PLAN REVIEW SHEET

Telephone: 704-353-0018 **Petition:** 2017-190

C4 Investments, LLC Email: bhorton@charlottenc.gov
Attachments: Bus stop bench pad detail

Below is an image of the standard detail (60.02A) for the requested bus stop bench pad. Permanent easement is requested, where dimensions exceed existing or proposed right-of-way limits.

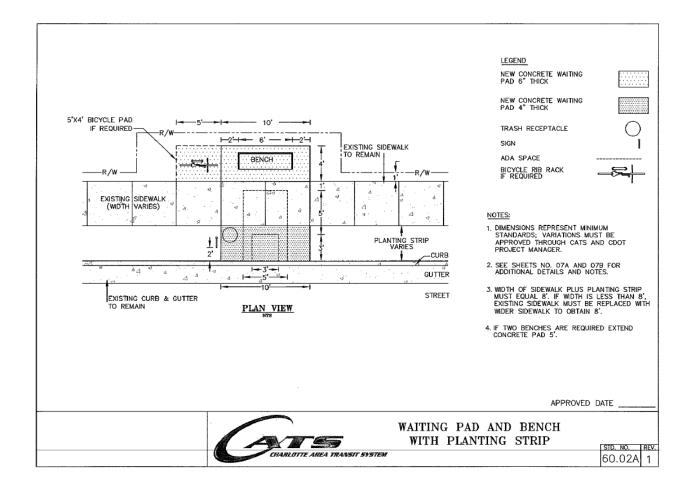
This site is located on an existing bus route from Sugar Creek LYNX Station on the LYNX Blue Line. The Petitioner is requested to provide and construct a new bench pad for a new bus stop on Sugar Creek Road along this site's frontage.
